Subject: **Umetco Minerals Corporation, Gas Hills, Wyoming, Site**
1. Response to Nuclear Regulatory Commission Letter dated April 18, 2018,
2. License Amendment Request

Reference: **Radioactive Materials License SUA-648; Docket No. 40-0299**

Attachment: Revised *Groundwater Monitoring Plan, Gas Hills, Wyoming*, April 2018 with and without edits

Groundwater Monitoring Plan Gas Hills, Wyoming

MONITORING LOCATIONS

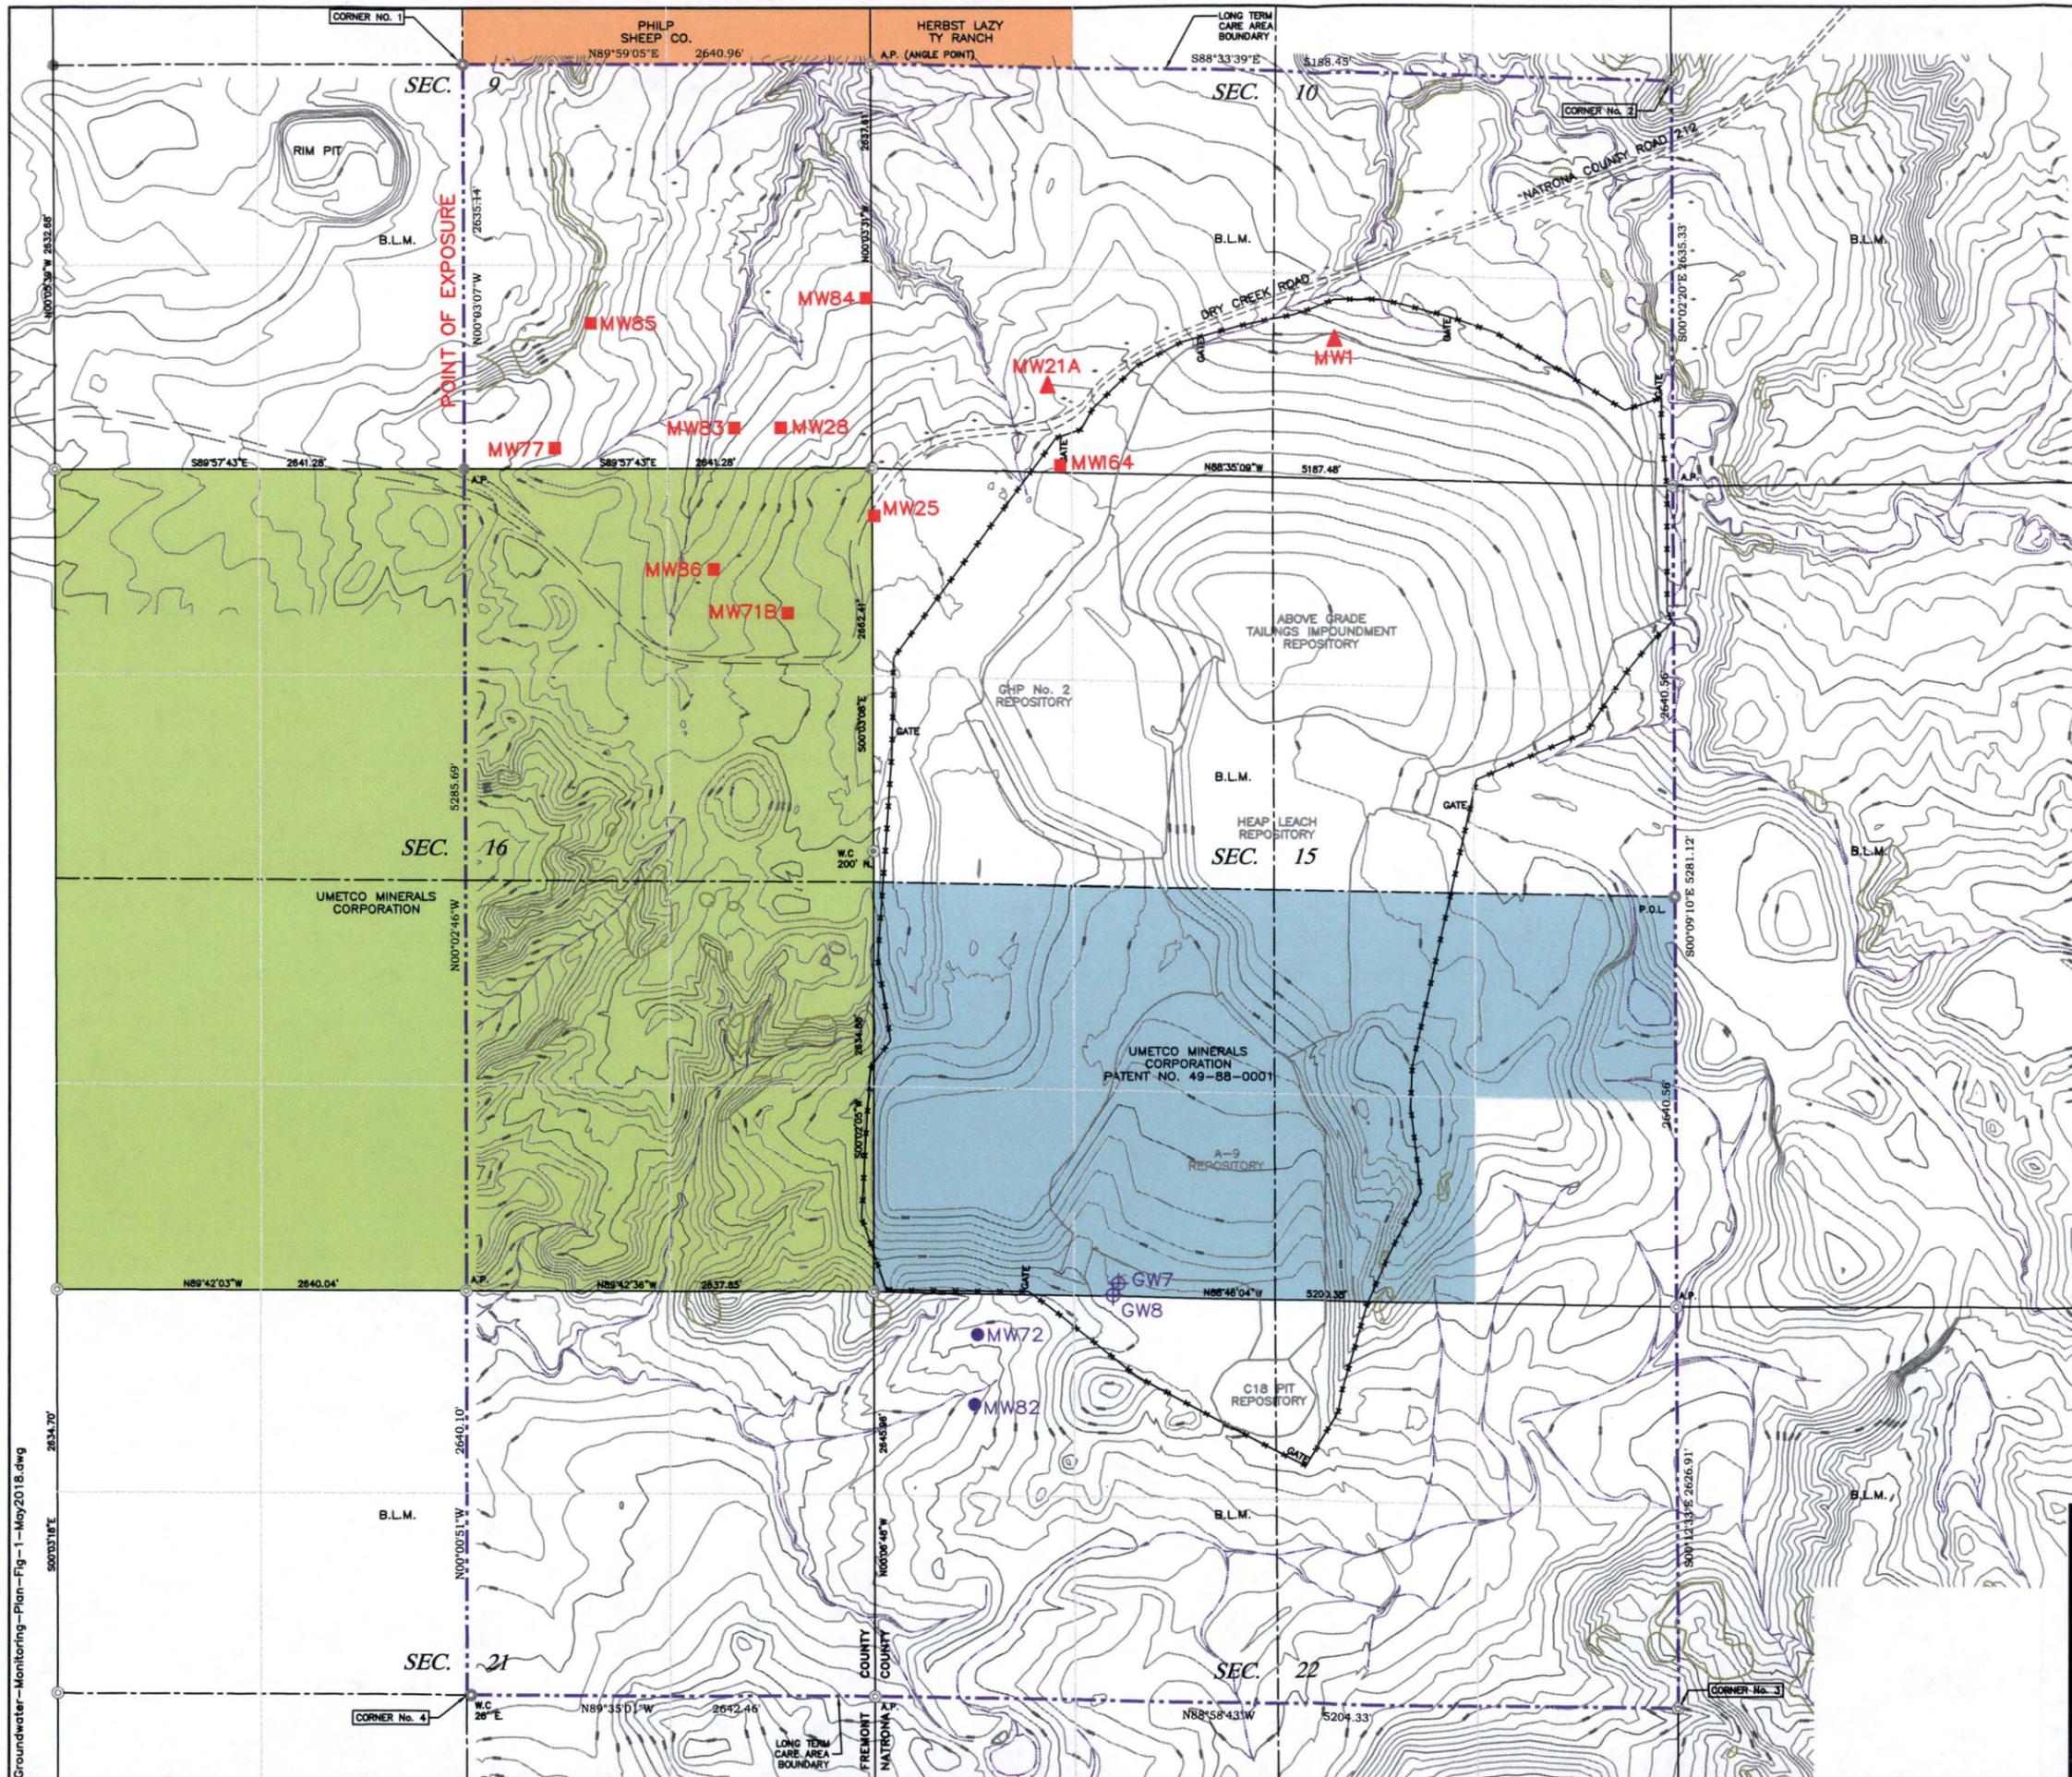
Umetco would like to revise the April 2015 *Groundwater Monitoring Plan* referenced by License Condition 35 to delete the sampling location known as Iron Springs.

The deletion of the Iron Springs sampling point will align the License's groundwater monitoring requirements with the requirements contained in DOE's Draft LTSP. Iron Springs is not a Point of Compliance (POC) location nor is it required to be monitored for Alternate Concentration Limit (ACL) constituents. In addition, Iron Springs is located over 6900 feet west of monitoring well MW77, the western most Western Flow Regime well which, as yet, is still unaffected by the mill-related groundwater plume. Based on Umetco's current estimation of a 0.33 feet per day groundwater velocity for the Western Flow Regime, it would take over 57 years for the water now seen in MW77 to reach Iron Springs. Monitoring well MW28, the most western well where radium has been detected over background concentrations, is approximately 8400 feet away and therefore the water seen at MW28 will not reach Iron Springs until even later.

To be consistent with DOE's Draft LTSP, and because Iron Springs is so far west of the plume and the Point of Exposure, Umetco proposes to remove Iron Springs as a sampling location from the *Groundwater Monitoring Plan*. The revised *Groundwater Monitoring Plan* is attached with and without edits.

Umetco would like to delete monitoring well MW70A from the April 2015 *Groundwater Monitoring Plan* referenced by License Condition 35 and abandon the well.

As detailed in Umetco's April 8, 2015 letter, Umetco proposed a monitoring well location to replace MW70A in order to address NRC's concerns of November 6, 2014, relating to uranium migration from MW1 and its non-concurrent decrease at MW70A, as well as Umetco's concern that MW70A appears to be providing consistent but perhaps erroneous data. Long-term monitoring of MW70A has indicated stagnant conditions which are not representative of either local groundwater conditions or upgradient groundwater conditions. As detailed in Umetco's April 2015 response letter, Umetco's evaluation of the historic uranium, chloride, and sulfate trends at MW1 and MW70A was inconclusive in determining evidence of groundwater migration from MW1 to MW70A, as seen by the inconsistent major ion signatures and expected travel times for the indicator constituent concentrations between the two wells. Additionally, trends in uranium and other constituents at MW70A have historically been uncharacteristic of site groundwater which leads Umetco to suspect stagnant conditions exist at MW70A and not representative of either local groundwater conditions, or of groundwater migrating from MW1.

Since the replacement well, MW84, approved for construction by License Amendment 74 dated January 19, 2017, was completed on October 17, 2017, and since MW84 has been screened in the same groundwater horizon as MW70A, i.e. in the upper portion of the aquifer and located in

a manner better suited to provide evaluation of radium attenuation, Umetco requests NRC concurrence to abandon MW70A.

Table 1 lists the POC and non-POC monitoring locations and details their corresponding monitoring requirements. Groundwater monitoring locations are shown on Figure 1 for both the Western and Southwestern flow regimes.

| Well Type | Western Flow Regime Wells ¹ | Southwestern Flow Regime Wells ² | Monitoring Requirements ³ |
|---------------------------------|--|---|---|
| Non-POC Wells | MW25 MW28 MWI64 MW71B MW77 MW83 MW84 MW85 MW86 | MW72 MW82 | Wells to be sampled annually for ACL constituents ^{1,2} , chloride and sulfate. Sampling to be conducted between May 1 st and July 31 st until license termination. The results to be used in tandem with results from POC wells in a groundwater conditions report submitted to the NRC, annually. |
